## Study of “Proposition baseline for Vacuum equipment layout in the TASX/P1 environment.”

- Introduction
- Detailed analysis for ECT movement of 400 mm on Standard Opening
- Conclusions from ATLAS TC

In order to solve the ones of the second groups, HL-LHC WP8 asked ATLAS to check the feasibility of moving ECT by 400 mm toward IP during Standard Opening. It will affect the Standard Opening **after LS3**.

Intermediate gap : between End cap calorimeter and JD

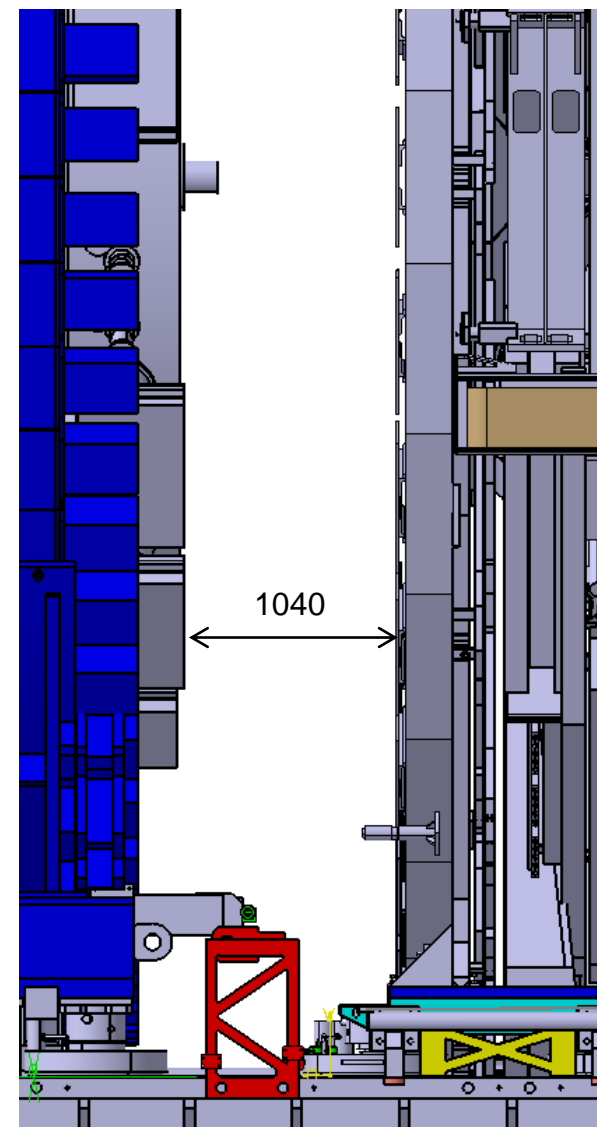
Nominal (and Minimal) clearance = 1040 mm

→ Scaffolding width = 890 mm

→ ATLAS 0.708° slope : +110 mm

→ Clearance between detector and scaffolding : + 20 mm  
on each side

The size of this gap is already at the minimal dimension,  
therefore there is no hope to recover any space from it.

Outer gap : between Small Wheel and ECT

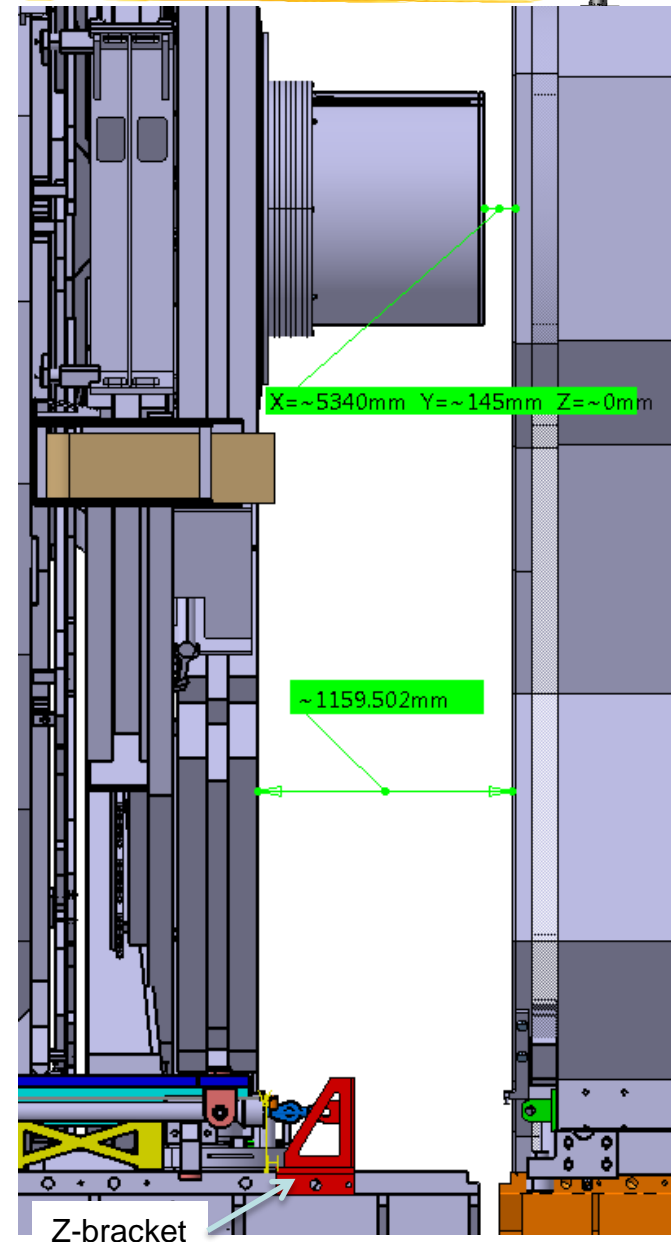
- 1- Nominal clearance is 1160 mm  
Minimal clearance = 1040 mm
  - Scaffolding width = 890 mm
  - ATLAS  $0.708^\circ$  slope : +110 mm
  - Clearance between detector and scaffolding : + 20 mm on each side

2- The gap 145 mm between ECT and JD centre tube is used to support the beam pipe during the shutdown.

Minimizing the gap from 1160 mm to 1040 mm makes the gap equal to 25 mm → a new support must be designed in agreement with TE/VSC (not critical)

3- It must be possible to connect the Z-bracket to the rail so that movement is feasible.

Outer gap : between Small Wheel and ECT (cont'd)

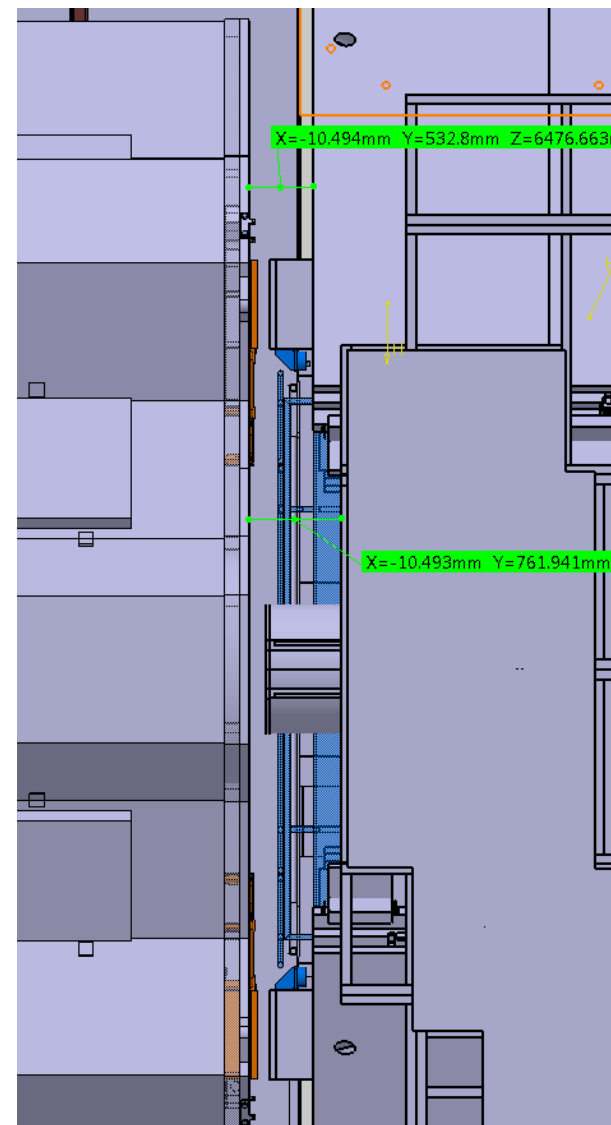
4- Access from the top allows to use the crane to carry material in the gap

- Z-brackets onto the rails (530 mm)
- Small elevator in sector 13 (760 mm)

This gap is also useful for some unforeseen activities like the removal of CSC chambers from SW-A during LS1.

## Outer gap

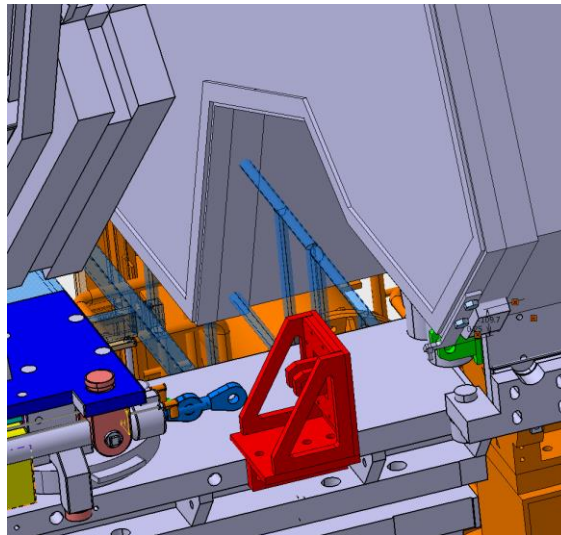
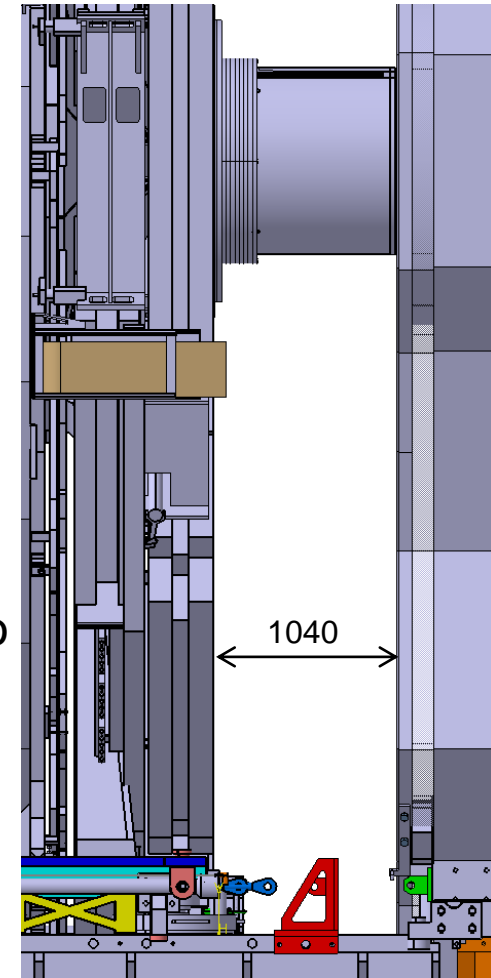
400 mm have to be saved, therefore outer and intermediate gaps have been resized at 1040 mm.  
Let's see the consequences.

The gap between JD centre tube and ECT is now limited to 25 mm → a new support must be designed in agreement with TE/VSC (not critical)

**The connection and use of the Z-bracket is still possible**

The handrail has to be modified in sector 13. The access there is more difficult from the trench (it is the current path to bring in scaffolding and other tooling)

## Outer gap (cont'd)

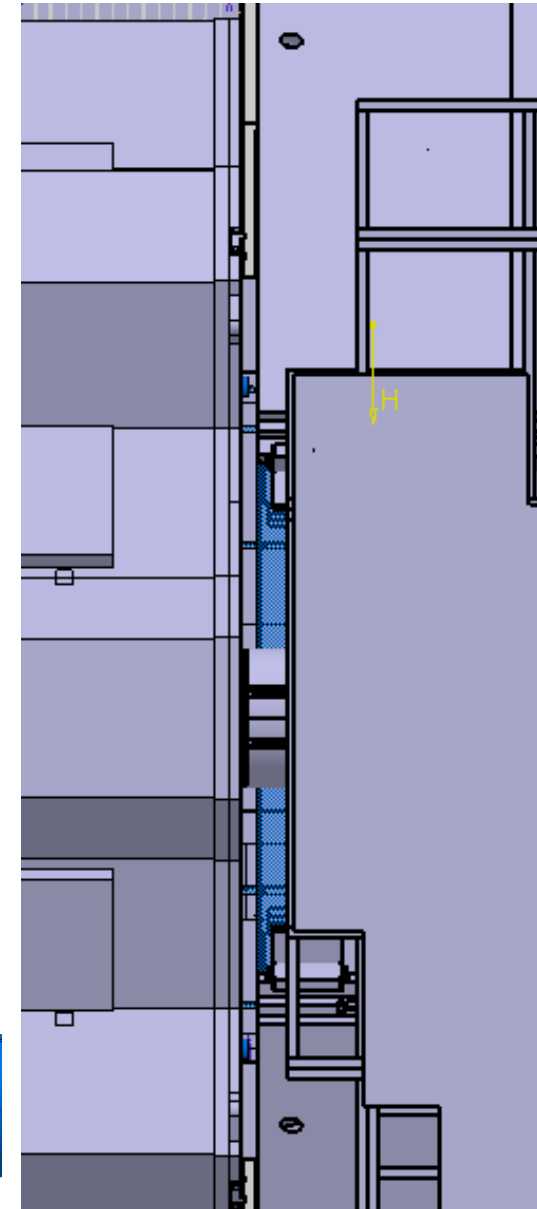
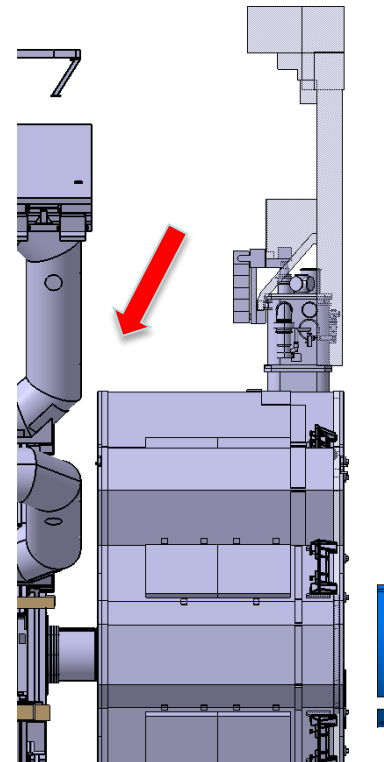
To use the crane to carry material in the gap is not possible anymore

- To carry Z-brackets onto the rails is an issue (90 kg each)
- Small elevator in sector 13 becomes impossible
- Study of ECT anti-seismic brackets has to be re-done, not easy because ECT sticks out of the Truck envelope.
- No crane access to Small Wheel

*Note : the top ECT platform, as well as the bridge platform at sector 5 are not shown, but the last one would need to be shortened.*

Intermediate gap : between End cap calorimeter and JD

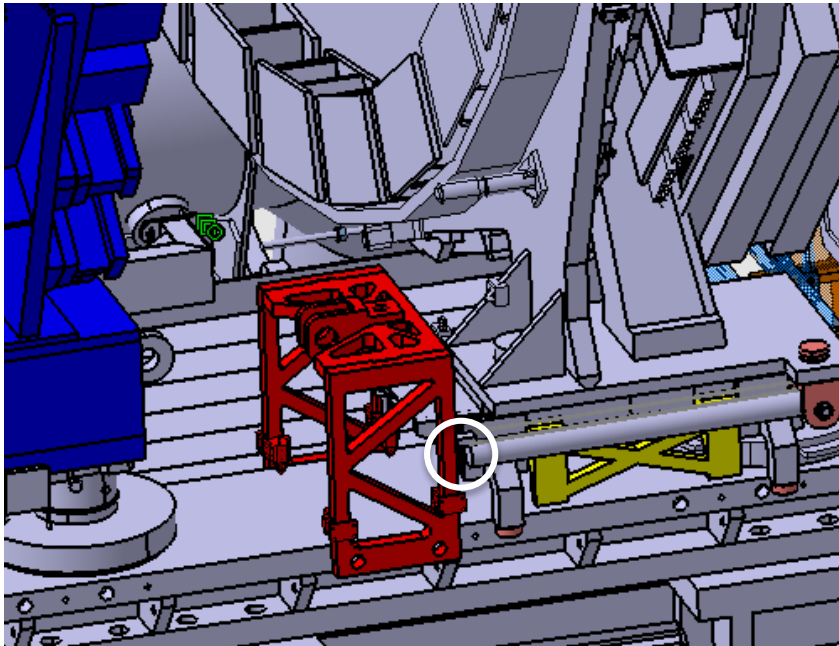
Nominal (and Minimal) clearance = 1040 mm kept unchanged

The gap is “just” moved toward IP by 280 mm.

According 3D model there is no additional conflict, however the Z-bracket is very close to be in contact with JD ( $\approx 1$  cm !)

Inner gap : between Barrel calorimeter and end cap calorimeter

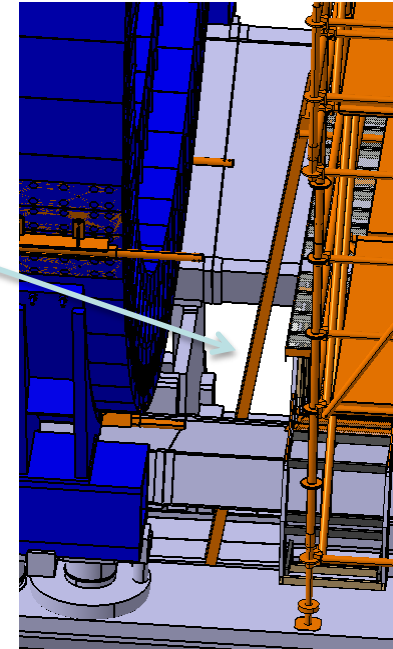
- Distance “Tile to Tile” is reduced to 2820 mm : it makes impossible the drawer extraction in one shot, but current idea of Tile group is to make shorter drawers anyway : to be carefully checked with Tile PL
- There is still no conflict with scaffolding or folding bridges when they are installed
- The access through Sector 13 ladder becomes very narrow (41 cm only !)
- The possibility to use the elevator to install the folding bridges and the scaffolding **has to be checked in detail**. The aperture goes down from 920 mm to 724 mm. The elevator width is 700 mm, but the  $0.708^\circ$  tilt has to be considered and some clearance for safety as well.
- It may be needed to modify the Liquid Argon purge line to match the new position of the end cap calorimeter (to be checked with cryogenics)

Comment : to move end cap calorimeter further, then built the access and finally move the calorimeter to final position is a doable process. But it would take about 1 more day on each side at opening AND closing.
